# Memo

**To:** Arkema Project File (ECSI 0398)

**Subject:** Alternative to Feasibility Study

The September 2023 *Feasibility Study* (FS), prepared by ERM, Inc., does not meet the minimum requirements described in the Oregon Administrative Rules Chapter 340-Division 122 (OAR 340-122), does not meet the minimum requirements described in Section VII.C.8 and VI.C.9 of Attachment B (Scope of Work) to the Order, and requires significant revisions to resolve DEQ's comments. DEQ believes that these revisions will require a considerable amount of time and effort, ultimately delaying important elements of the cleanup work needed to address risks to human health and the environment.

**Figure 6-2**  
 Groundwater Functional Units Feasibility Study  
 Arkema Inc.  
 Portland, Oregon

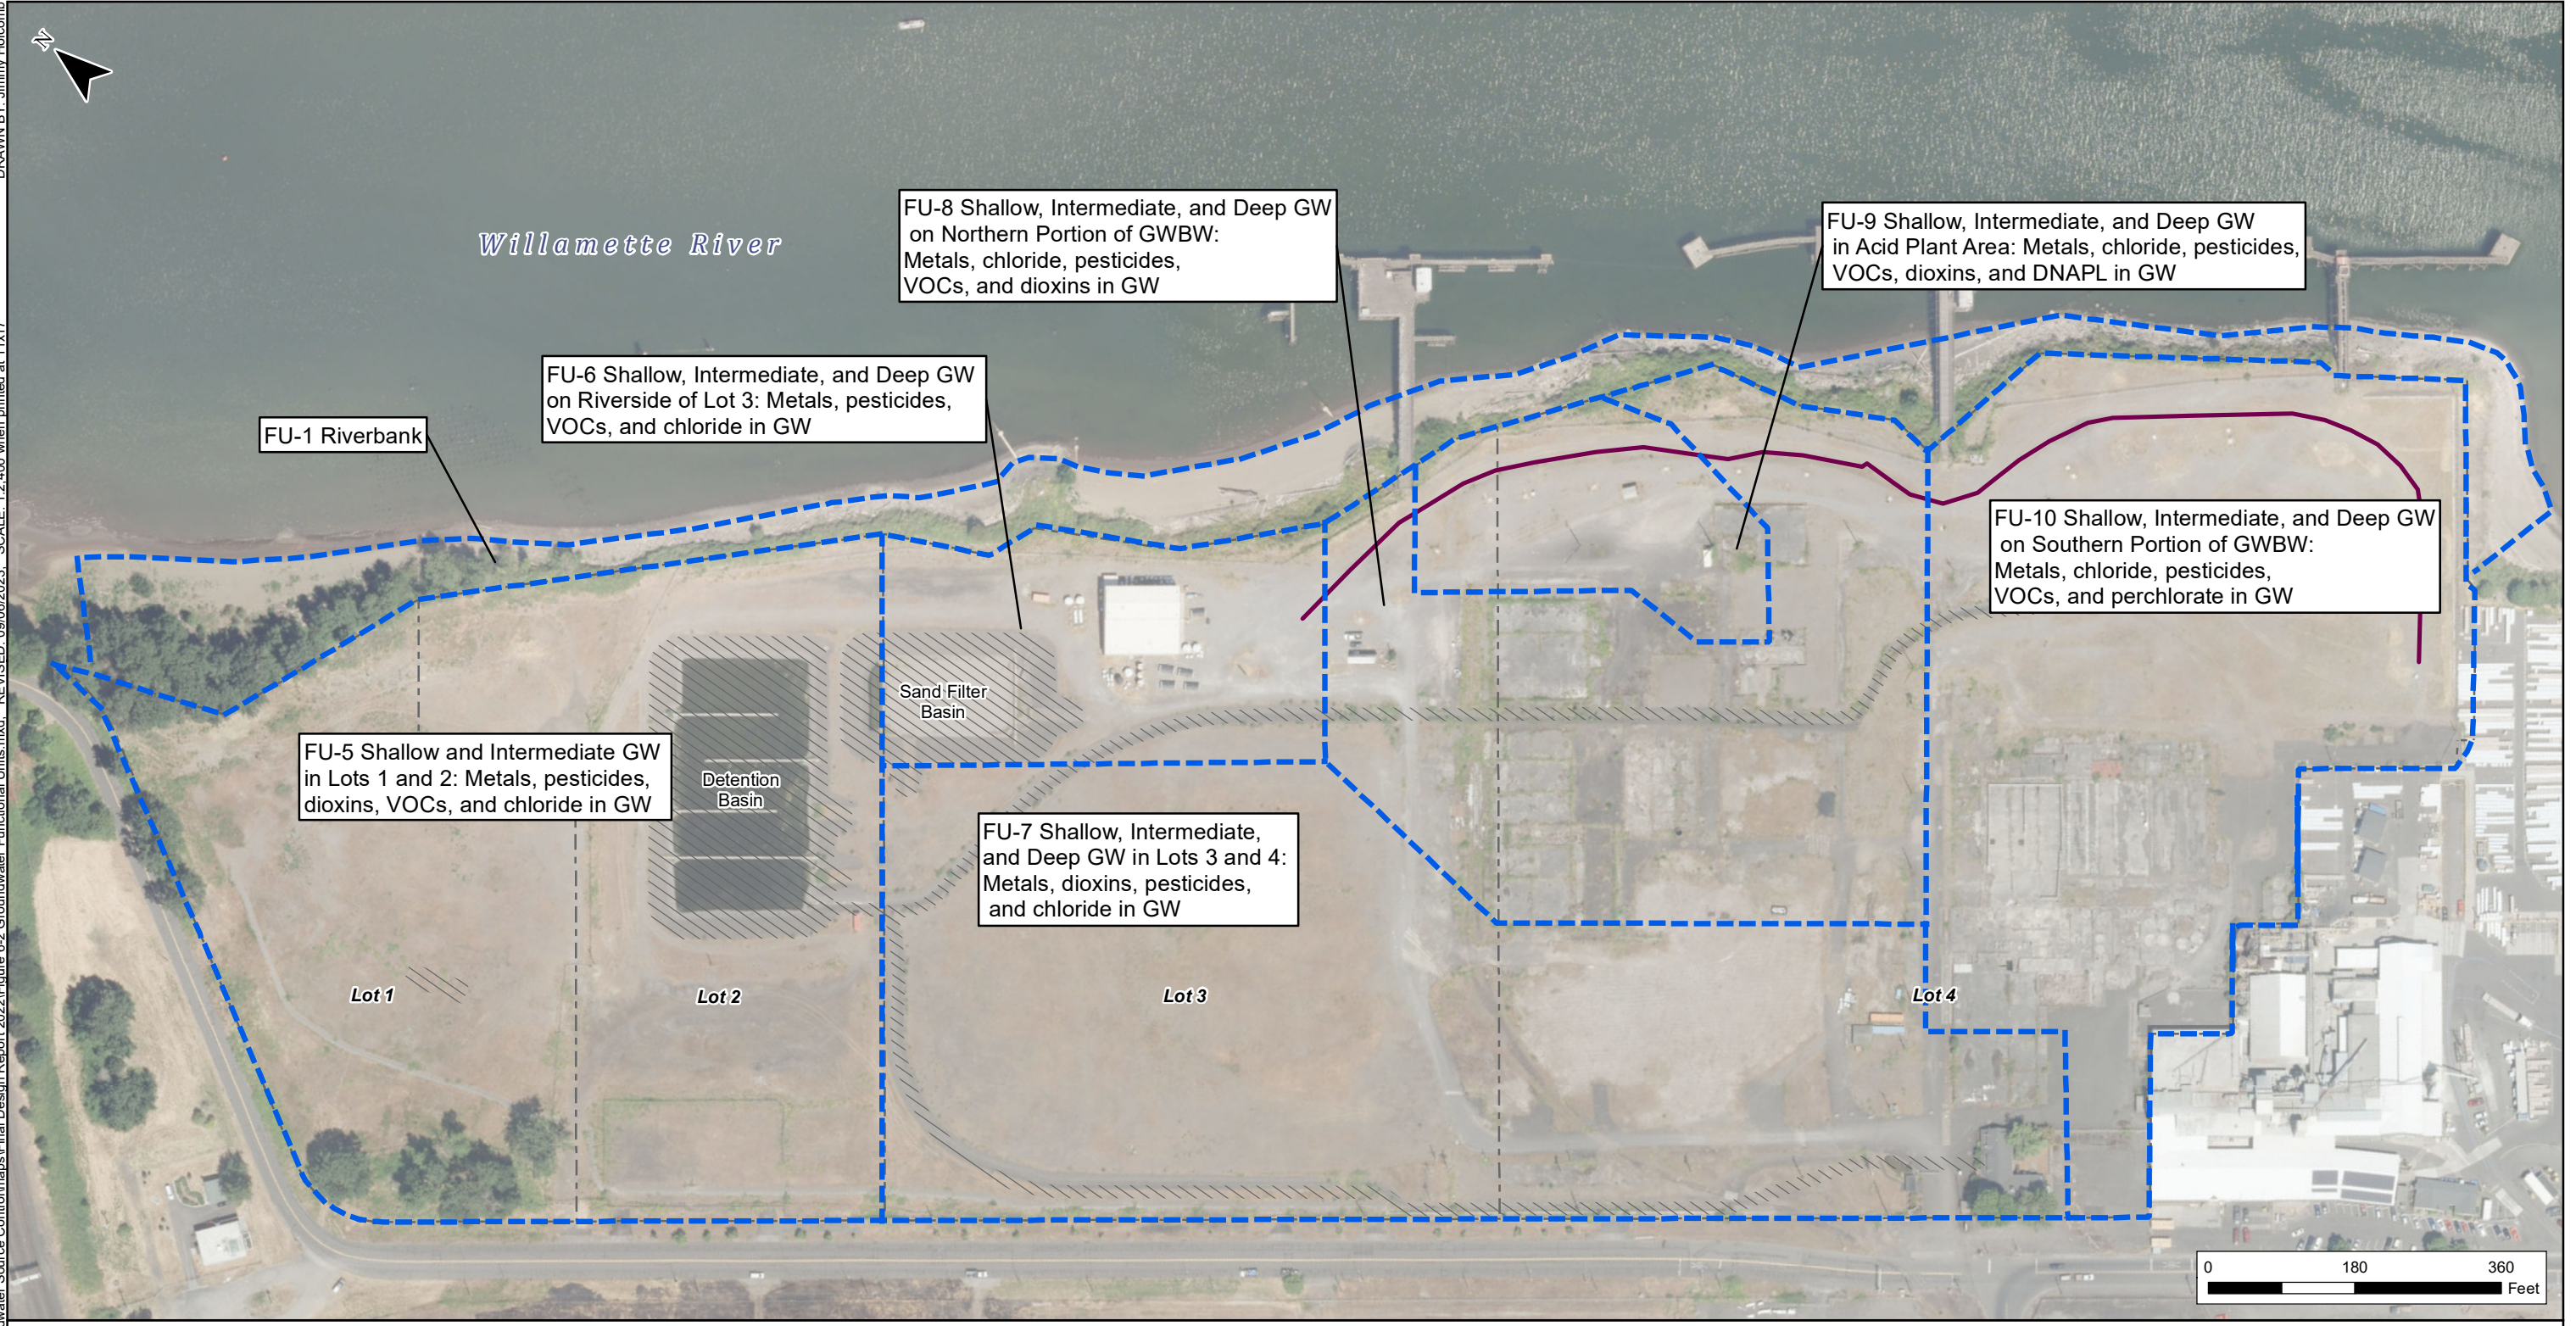
- 1) Implement four IRAMs consisting of:
  - a) IRAM 1 – Acid Plant Soil/NAPL (ISS) and Groundwater ISCR - Insitu Solidification and Stabilization (ISS) combined with enhanced insitu chemical reduction (ISCR) of non-aqueous phase liquid (NAPL) in soil and groundwater (located within Acid Plant Area (functional unit [FU]-4 and FU-9). The FS recommends ISS of NAPL and enhanced ISCR as the remedial action for Acid Plant groundwater and coincident ISS of NAPL in Acid Plant soil. (Note. the FS recommends implementing this action as part of the first phase of the remedial action [Section 9.4 #2].)

- b) IRAM 2 - Enhanced ISCR of perchlorate and hexavalent chromium located within Chlorate Plant Area/Salt Pads (FU-10). (Note. the FS recommends implementing this action as part of the first phase of the remedial action [Section 9.4 #4].)

- c) IRAM 3 - Remove all currently known human health direct contact hot spots not addressed by other IRAMs.
  - d) IRAM 4 - Enhanced ISCR of dissolved chlorinated VOCs and perchlorate located within Northern Groundwater Barrier Wall Area (FU-8) and Acid Plant (FU-9)

groundwater. The FS recommends ISCR injections and enhanced ISCR to address chlorinated VOCs these areas. (Note. the FS recommends implementing this action in Acid Plant groundwater (FU-9) as part of the first phase of the remedial action [Section 9.4 #2] and in Northern Groundwater Barrier Wall Area groundwater (FU-8) as part of the second phase of remedial action [Section 9.5].)
